## **BID ADDENDUM NO. 3**

### **Johnson Student Center**

### **Building Demolition, Increment 1 (Demolition) and Increment 2**

RANCHO SANTIAGO COMMUNITY COLLEGE DISTRICT  
SANTA ANA, CA

**ALUMINUM SIGN SECTION** 1 1/2" = 1'-0" 17

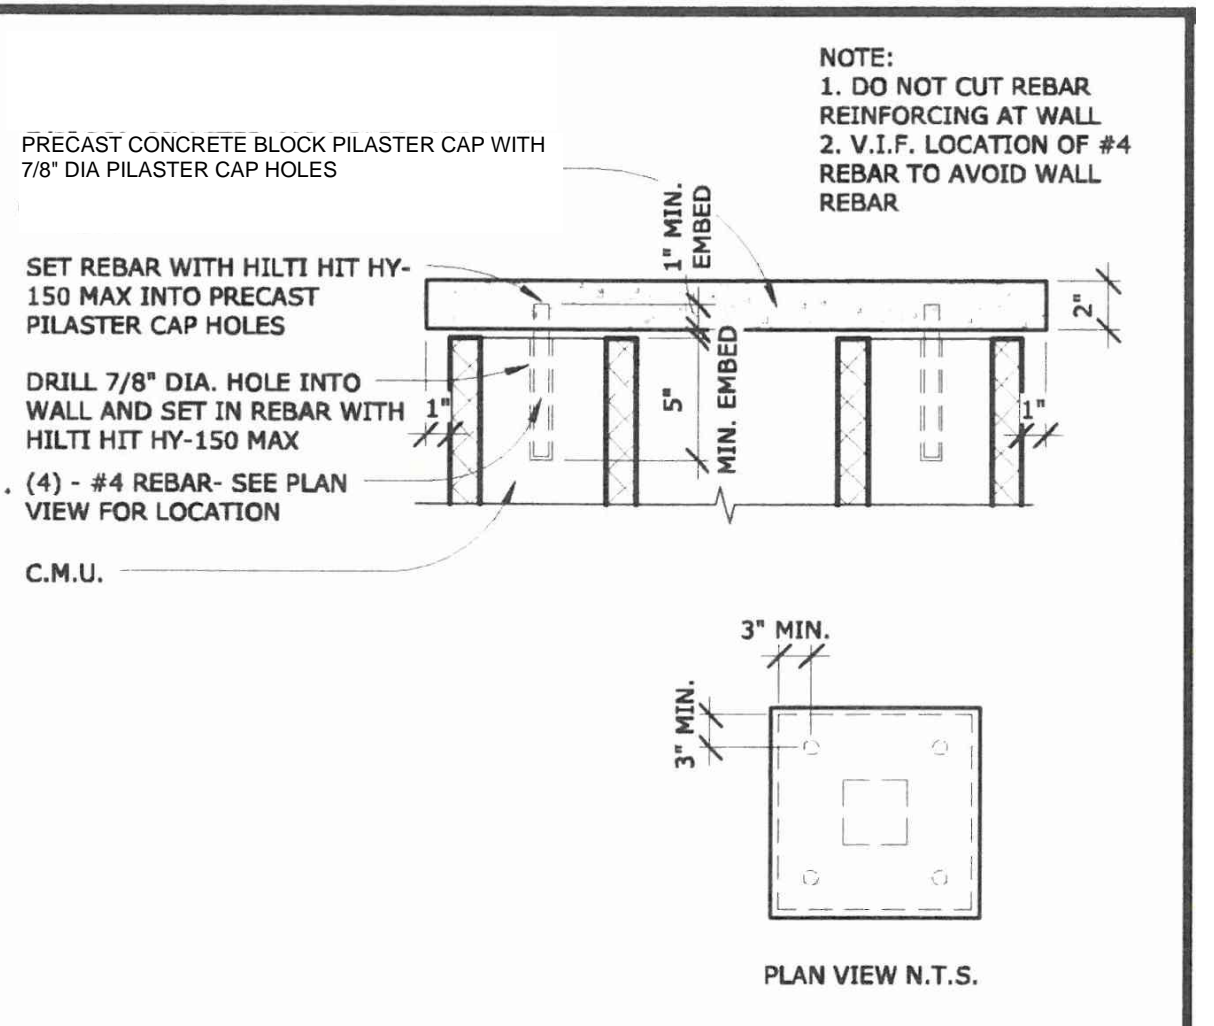
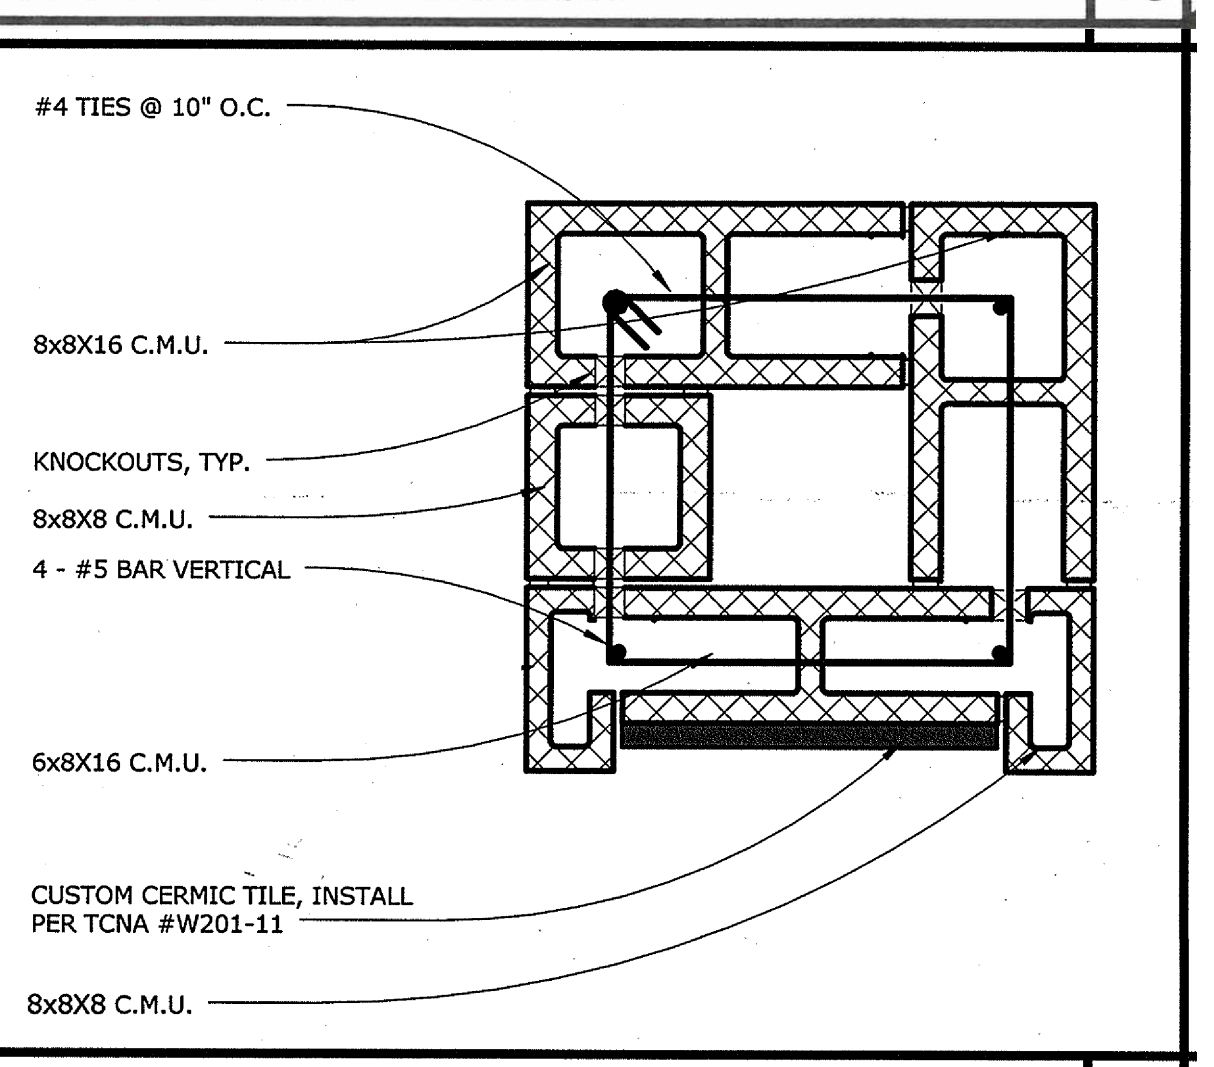
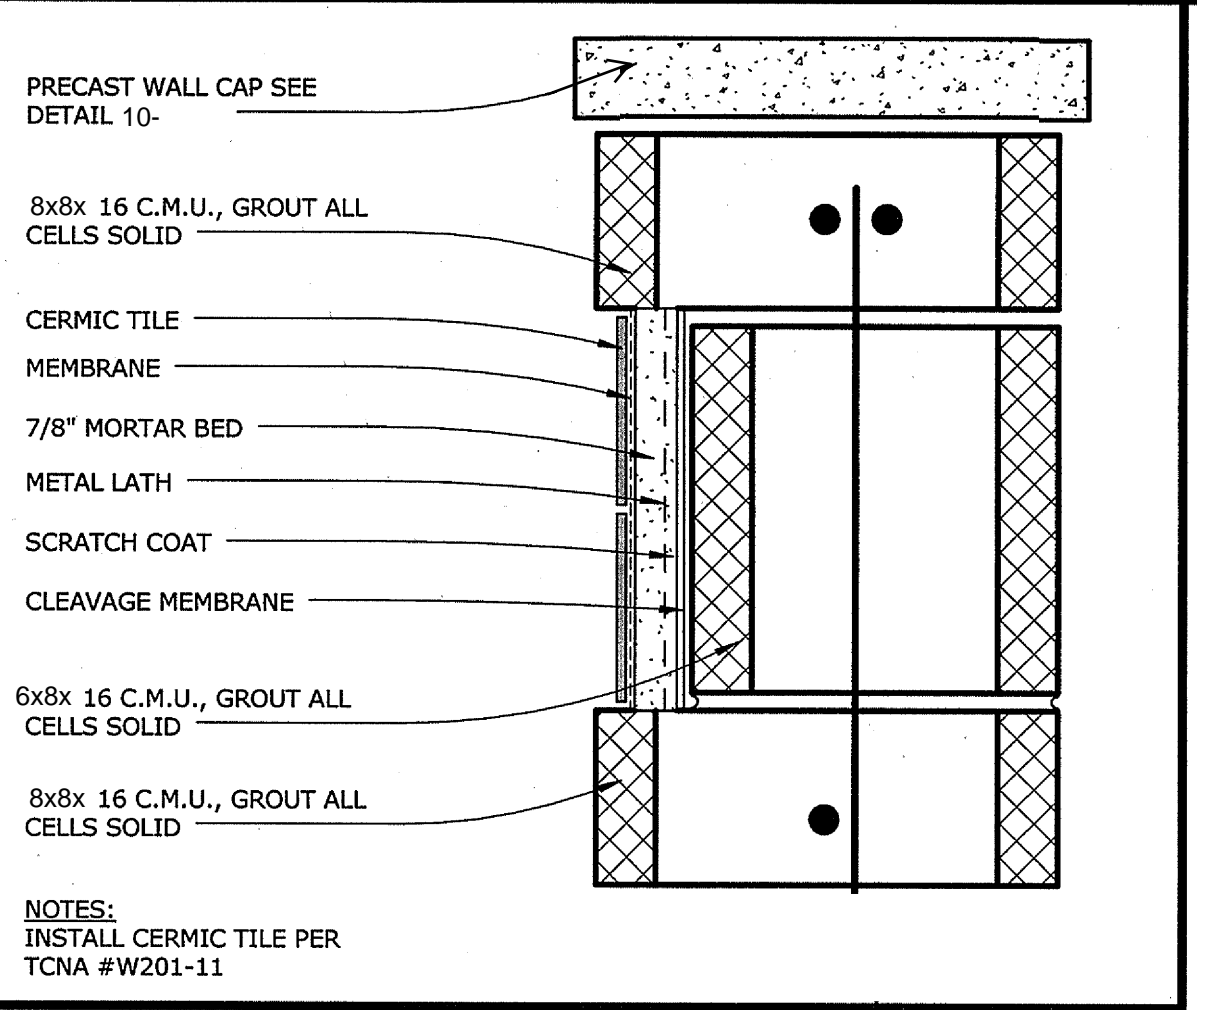
- Increment 2
  - i. General Contractor to provide an Exterior Material Mock-Up, refer to design drawings. Reference new sheets A0.01 and A0.02
- Increment 2
  - i. Added new detail sheet G3.12 (signage details) for monument / site signs.

- a. SERVICE YARD TO BE SPLIT FACE COLOR "SHORELINE"
  - b. PROVIDE: 8"h CMU, ANGELUS BLOCK - PRECISION "SHORELINE"
  - c. PROVIDE: 8"h CMU, ORCO BLOCK CO/WHITE - SPLITFACE 2-SIDES, MEDIUM WEIGHT BELOW THE SQUARE PRE-CAST CONCRETE BLOCK PILASTER 2" CAP.
- REFER TO NEW DETAIL SHEET G3.12 FOR ADDITIONAL INFORMATION**

C1.00

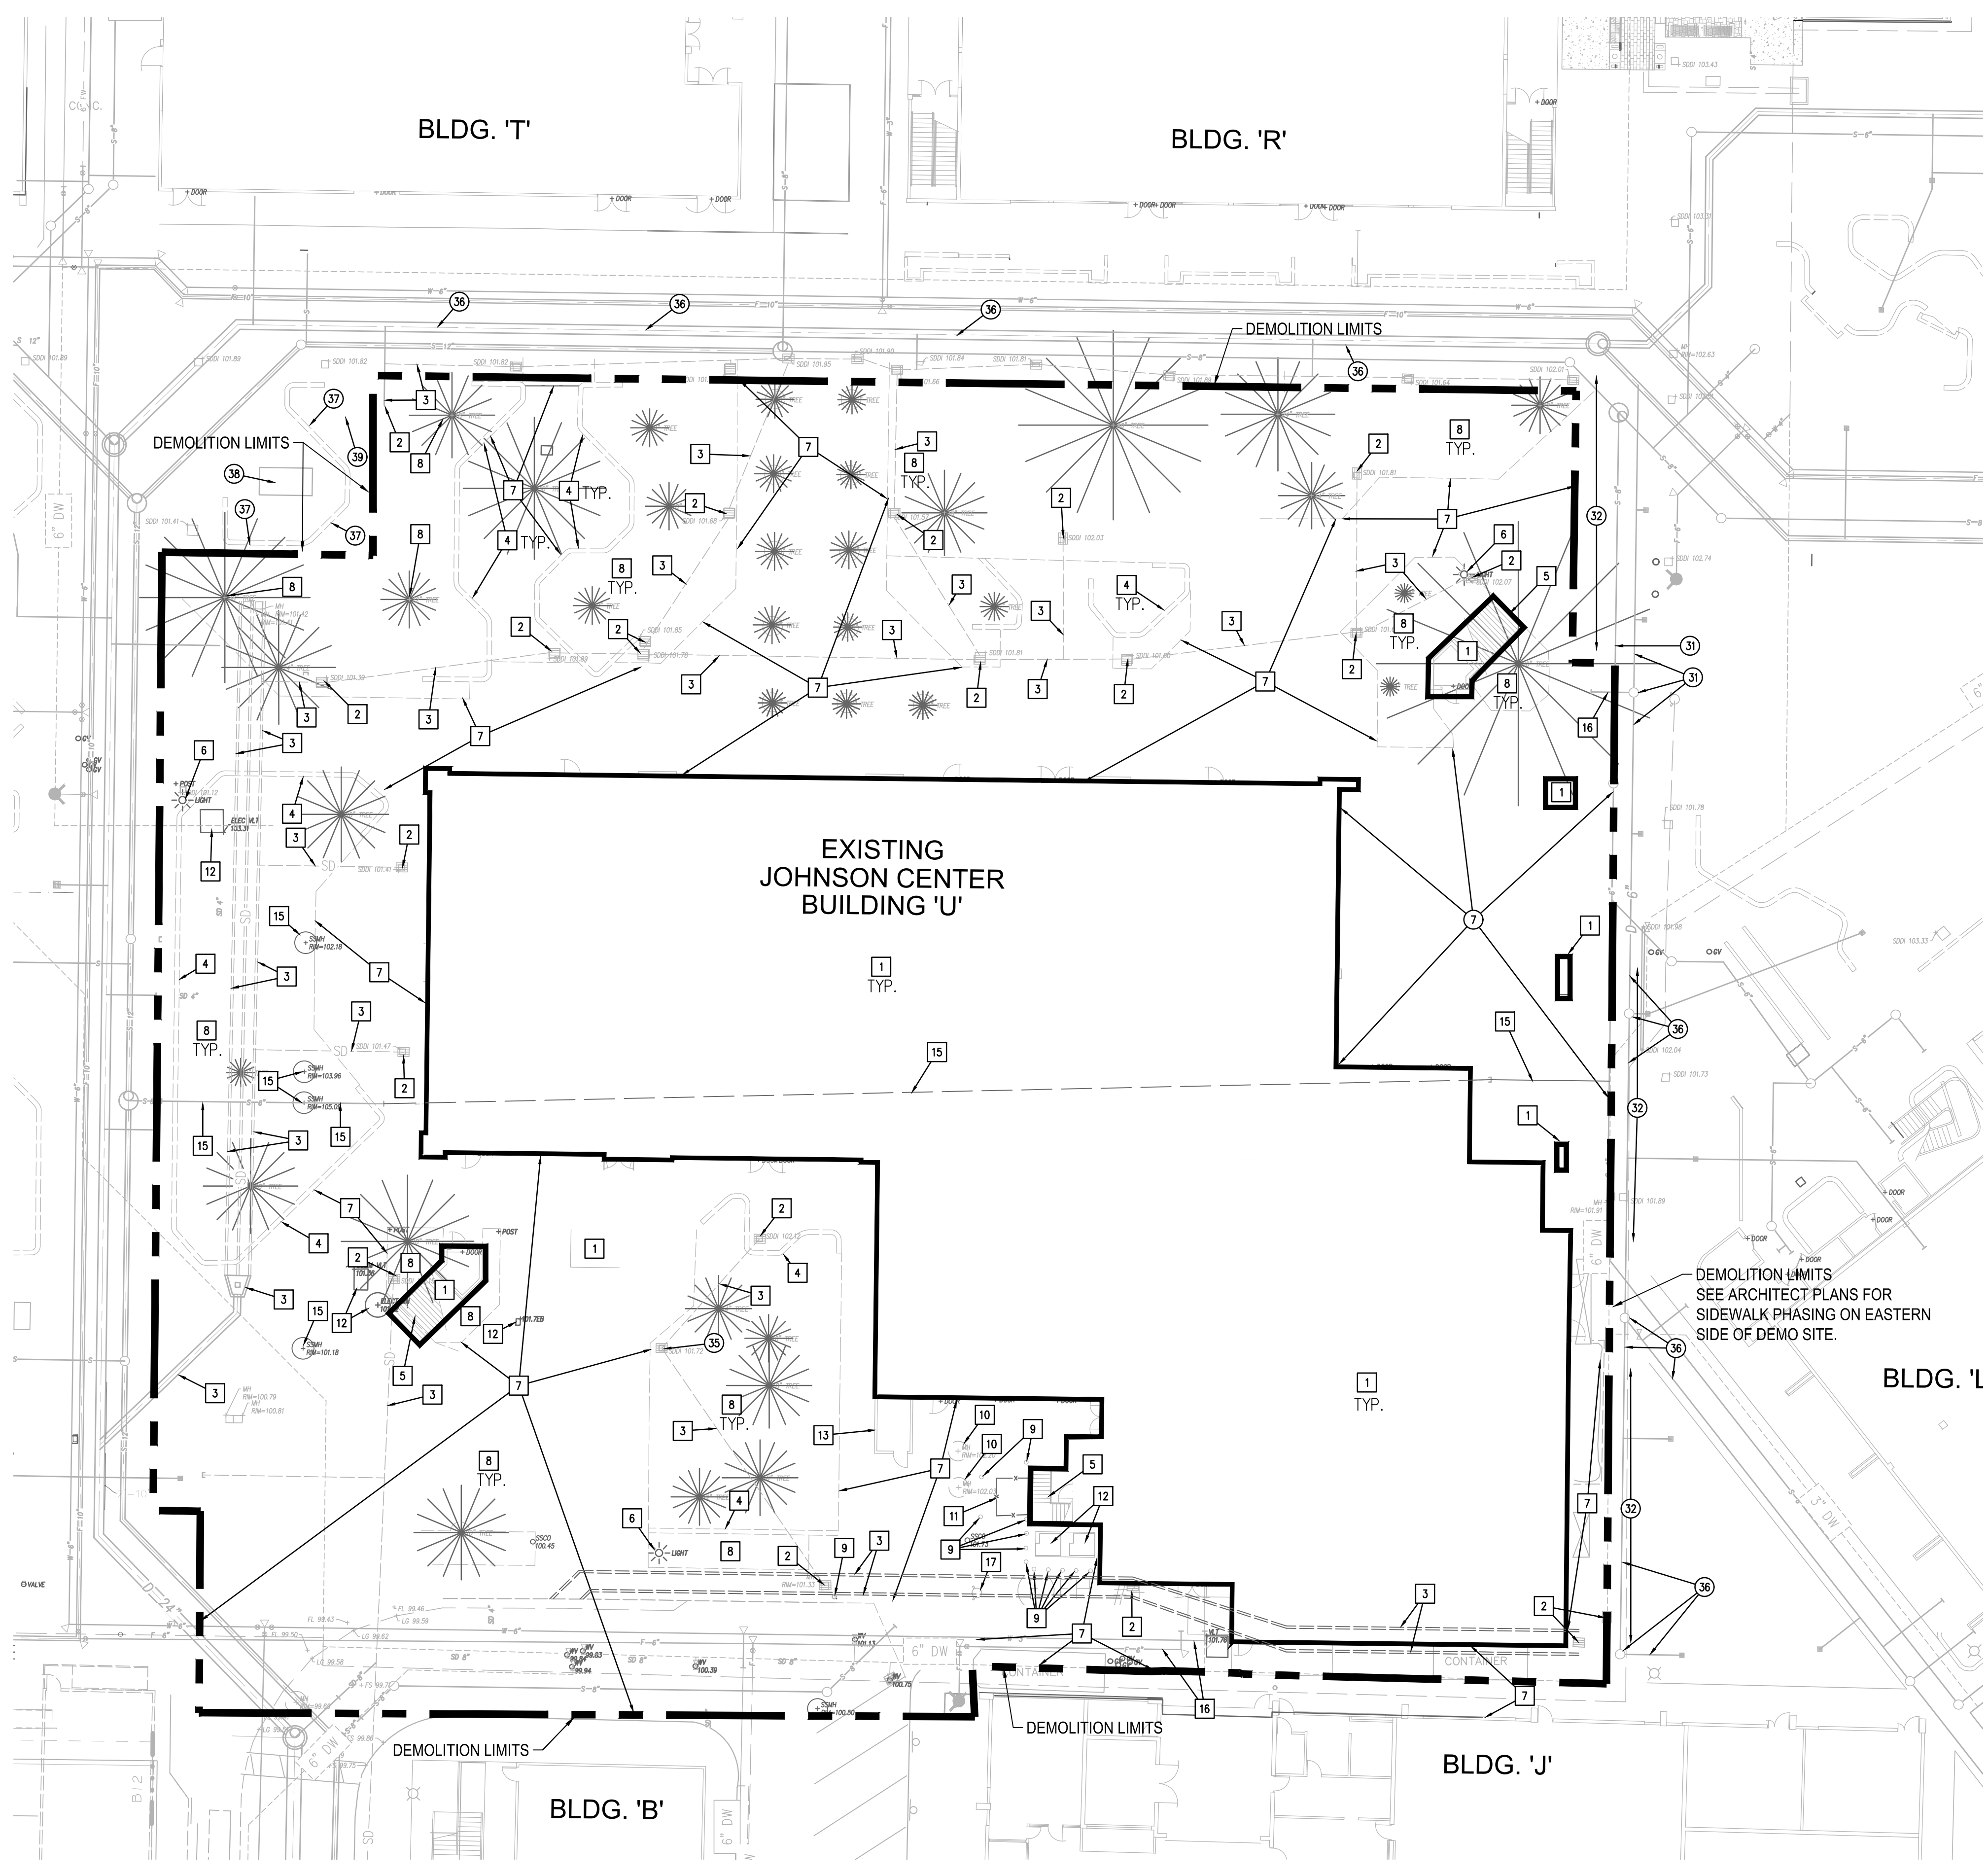
- Building Demolition
  - i. Revised sheet C1.00, refer to clouds and delta 3
    - 1. Refer to landscape, hardscape, underground wet/dry utilities being removed/demoed in their entirety in lieu of being protected.
    - 2. Revised/removed notes as needed for phasing of work with increment 1 and 2.
  - ii. Remove sheet C2.00 in its entirety and refer to Increment 1 and 2 erosion control and grading plans.
- Increment 2
  - i. Modifications to the West Plaza: The proposed sewer lateral, serving the West Plaza kiosk, connected to the existing 12" sewer line east of the plaza. Due to conflicts with the kiosk footing and the layout of the proposed sewer later, the lateral point of connection was revised and is now proposed to connect to the existing sewer line, running east/west through the West Plaza site. Refer to SKC-3.01

DATE:	09/18/2018		
FROM:	S.Monsen - McCarthy	EMAIL:	SMonsen@McCarthy.com
SPECIFICATION NUMBER:		DRAWING NUMBER:	Building Demo - Sheet C1.00
REQUESTED CLARIFICATION:			
Building Demo - Sheet C1.00, Grading Note 2 refers to the City of Cerritos. Please confirm this should be Santa Ana instead.			
RESPONSE TO CLARIFICATION, <b>SUBMITTED AS PART OF AN ADDENDUM:</b>			
<b>CONFIRMED TO READ CITY OF "SANTA ANA" . REFER TO REVISED SHEET C1.00</b>			
RESPONSE PROVIDED BY:	Linda Sandusky / H&F	DATE:	09/24/18

DATE:	09/18/2018		
FROM:	S.Monsen - McCarthy	EMAIL:	SMonsen@McCarthy.com
SPECIFICATION NUMBER:		DRAWING NUMBER:	Building Demo - Sheet C1.00
REQUESTED CLARIFICATION:			
<p>Building Demo - Sheet C1.00 - Detail 1 - There are several utility structures &amp; piping that are listed as "Protect in Place", however these will need to be removed. Please revise this drawing to show which specific utility items are to be protected in place &amp; which are to be removed, especially those that are in the zone of the building over excavation.</p>			
RESPONSE TO CLARIFICATION, <b>SUBMITTED AS PART OF AN ADDENDUM:</b>			
<p><b>REVISED SHEET C1.00 DETAIL 1 TO SHOW ALL WET/DRY UTILITIES AND ALL ASSOCIATED ACCESSORIES TO BE REMOVED IN THEIR ENTIRETY AND CUT BACK/CAPPED IF NECESSARY AT BOUNDARY OF CONSTRUCTION</b></p>			
RESPONSE PROVIDED BY:	Linda Sandusky / H&F	DATE:	09/24/18
